**Independent Qualified Registered Professional Engineer
Support to Demonstration Bulk Vitrification Project**

IQRPE Design Assessment Report No. DR-009, Rev. 1

**Demonstration Bulk Vitrification System IQRPE/RCRA
Design Review Package, RPP-24544, Revision C**

**Section 2.2, Waste Dryer System
(90 Percent Design)**

1. **Drawing F-145579-33-A-0100, Rev N, “Bulk Vitrification Waste Dryer P&ID”**
2. **Drawing F-145579-33-A-0101, Rev M, “Bulk Vitrification Waste Dryer Vacuum P&ID”**

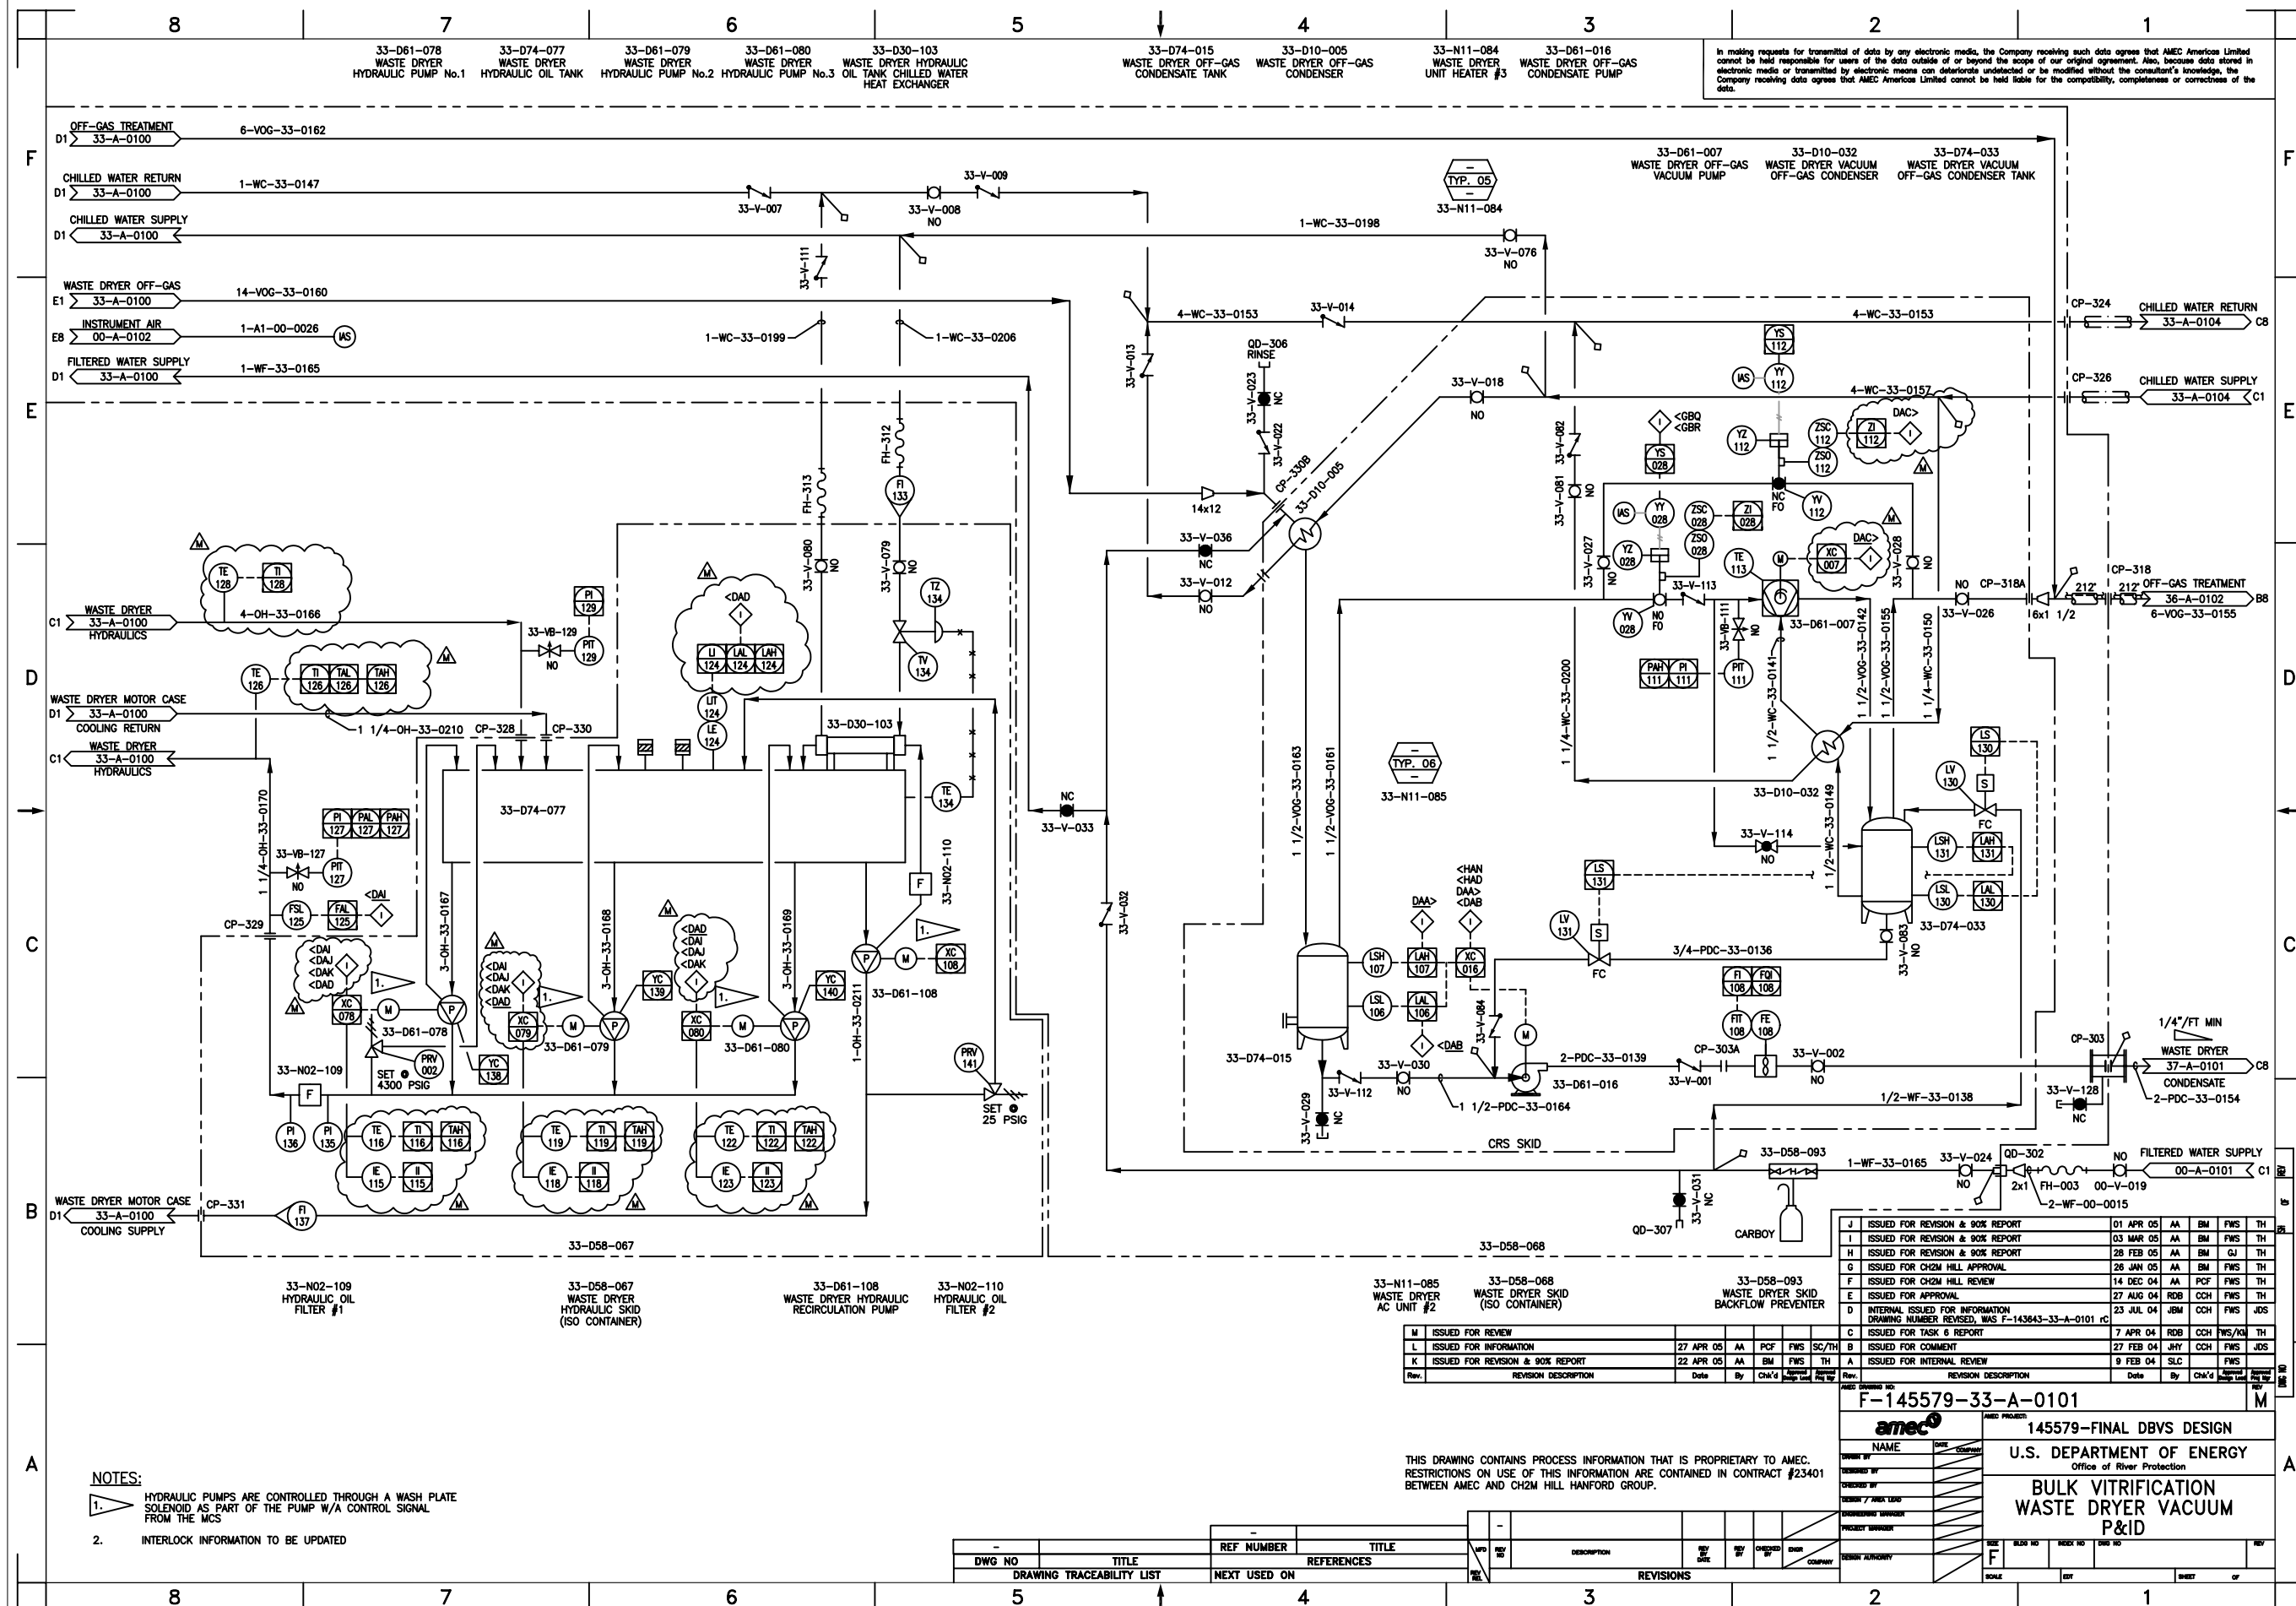
The Waste Dryer Hydraulic drive system is included in scope for the Dryer System per specification 143643-D-SP-001. Hydraulic tank 33-D74-077 shown on F-145579-33-A-0101 does not show an atmospheric vent nor overpressure protection. Relief protection is required for the hydraulic tank, unless this is designated and shown to be an atmospheric vented tank. Overpressure protection of hydraulic pumps and piping is included in the design.
